Technical Service Bulletin

NUMBER: 24-23-99

Revised Air Conditioning Suction Line And Unified Line Installation Instructions

2000 (PL) Neon (Left Hand Drive Only)

FIGURE 1

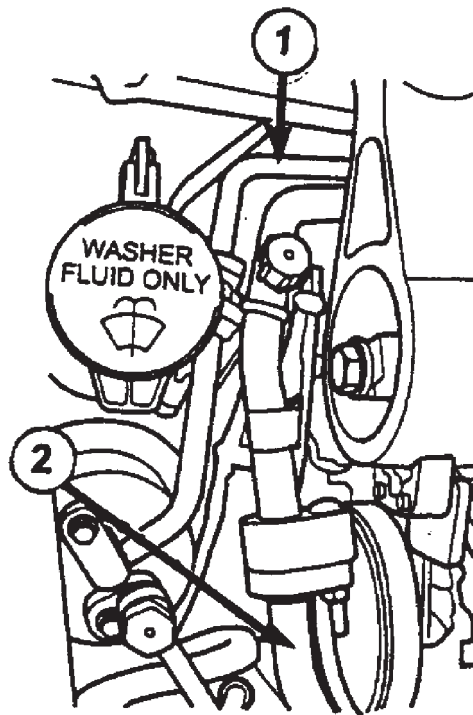
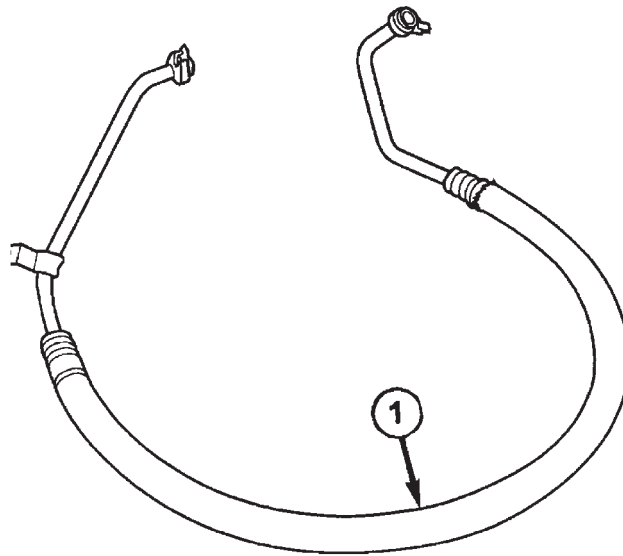
2. Remove and discard the A/C unified line by removing the bolt at the filter drier bottle, the bolt at the dash panel and the bolt at the suction port of the compressor. Do not remove the filter/drier bottle and liquid line. Do not leave the filter/drier bottle exposed to air for any length of time to prevent moisture contamination.
3. Place a rag over the power steering belt to catch oil drips.
4. Install the new A/C suction line (p/n 05278761AB) and A/C unified line (p/n 05015344AC). The new suction line will use the alternate A/C compressor bolt hole. Torque the bolt at the dash panel to 22.5 Nm (200 in.lbs). Torque the nut/stud to 11.8 Nm (105 in.lbs). Torque the filter drier bolt to 11.2 Nm (100 in.lbs). Torque the A/C compressor bolt to 12.2 Nm (108 in.lbs). (Figures 1 and 2).

FIGURE 3

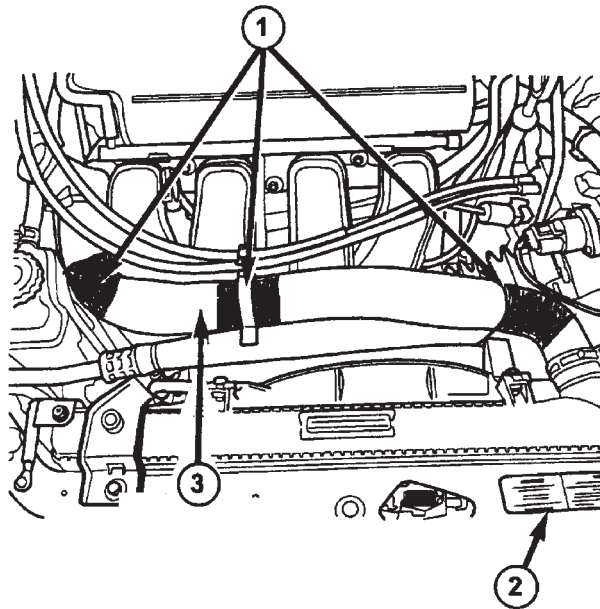
5. Evacuate the A/C system.
6. Siphon enough coolant through the coolant cap to allow removal of the upper radiator hose.
7. Install the radiator hose sleeve (05017627AA) by sliding the braided sleeve over the hose. Secure the hose with the three rubber bands provided (Figure 3).

- 12. Install the new A/C underhood specification label (p/n 05264840AC) over the existing label (Figure 3).

FIGURE 4

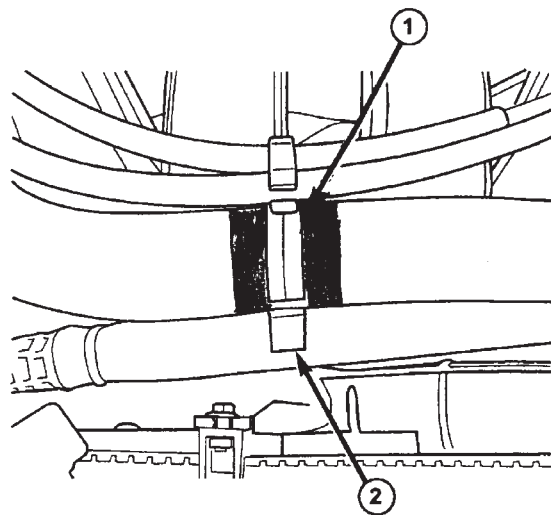
8. Install the accelerator cable clip over the center rubber band (Figure 4).
9. Install the fan shroud clip (p/n 05278762AA) with the existing left side cooling fan shroud mounting bolt and torque to 7.3 Nm (65 in.lbs) (Figure 5).

FIGURE 6

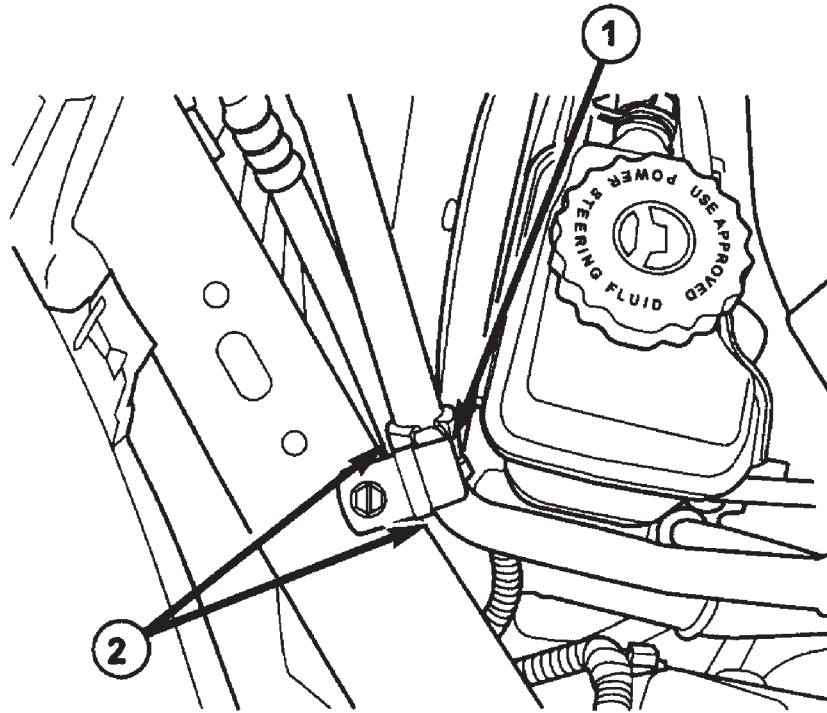
NOTE: ENSURE THAT THE PILOT HOLE IS POSITIONED SO THAT THE CLIP DOES NOT CONTACT THE POWER STEERING RESERVOIR (FIGURE 6). ALSO ENSURE THAT THE ALUMINUM TUBING DOES NOT CONTACT THE SHEET METAL OR A BUZZ MAY OCCUR.

11. Using the scribe mark made in step 10, drill a 7/32 pilot hole into the radiator crossmember. Install the crossmember clip screw (p/n 06505529AA) and torque to 7.3 Nm (65 in.lbs).
